UNITED STATES PATENT AND TRADEMARK OFFICE

APPLICATION NO.	FILING DATE	FIRST NAMED INVENTOR	ATTORNEY DOCKET NO.	CONFIRMATION NO.
10/622,621	07/18/2003	Jan Weber	S63.2-10856-US01	2650
499 7590 12/24/2008 VIDAS, ARRETT & STEINKRAUS, P.A. SUITE 400, 6640 SHADY OAK ROAD EDEN PRAIRIE, MN 55344				
EXAMINER				
KOHARSKI, CHRISTOPHER				
ART UNIT		PAPER NUMBER		
3763				
MAIL DATE		DELIVERY MODE		
12/24/2008		PAPER

Office Action Summary

DETAILED ACTION

FIG. 2

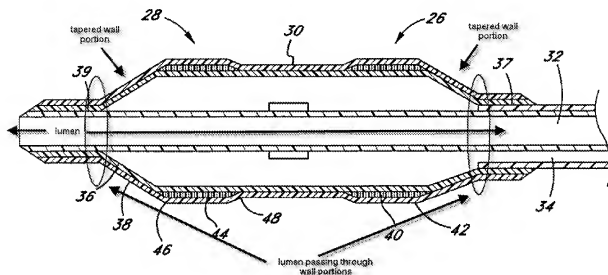
Regarding claims 27-29, 32-37 and 65-68, Crocker et al. discloses a medical balloon (18) having a longitudinal axis and proximal (26) and distal (28) ends, the balloon formed of a polymer material (col 6, ln 25-40), the balloon connecting to a coaxial shaft (37) at a proximal end thereof and connecting to the same or a different coaxial shaft at the distal end thereof (39), and having a central body wall portion (30) between each end spaced apart from the balloon ends and connected thereto by means

of tapering proximal and distal wall (38, 42) portions, respectively, wherein the balloon further comprises a lumen (32) extending longitudinally therethrough, said lumen passing through the proximal and distal wall portions of the balloon (Figures 1-4).

Crocker et al. discloses a polymeric (cross-linked polyethylene, col 7, ln 35-55) balloon and is a multi-layer polymeric film (39, 36, 38, 40, 42, 44) wherein a first (36, 48) and second layers are in adherent contact over a coplanar coextensive region defining an at rest and open configuration resulting in a change of surface area (Figures 2-3), with a layer comprising an elastomeric band (40, 44) that is stretched during the configuration change. Examiner asserts that the radiation cured polymer is a product by process limitation in which the resultant radiation cross-linked product is indistinguishable from the heat cross-linked polyethylene of Crocker et al.

Regarding claims 27 and 63, Examiner asserts that the balloon pictured in Figure 2 meets the claim limitations as claimed. The lumen (32) of Crocker et al. passes *through the tapering distal and proximal wall portions* (38, 42) of the balloon. Examiner asserts that the language as claimed is insufficient to overcome the prior art of record, the broadest reasonable of the definition of "extending through" is "passing or extending from one end, side, or surface to another" "*through.*" *The American Heritage® Dictionary of the English Language. 2007.* Therefore Examiner asserts that the lumen (32) of Crocker et al. indeed passes through the tapering distal and proximal portions as claimed.

Regarding claim 32, Examiner asserts that the first (36) and second balloon (48) layers of Crocker et al. meet the claimed limitations of "having an at-rest configuration defining an at-rest area on said respective outer and inner surfaces corresponding to said coextensive area, the at-rest area of said first layer outer surface being smaller

than the at-rest area of said second layer inner surface." Examiner asserts that the outer surface of the first layer (36) has a smaller surface area than the inner surface of the second layer (48) because of the stretched areas (near 44 and 40) which are present to accommodate the expansion limiting bands and that the second layer must cover the first layer.
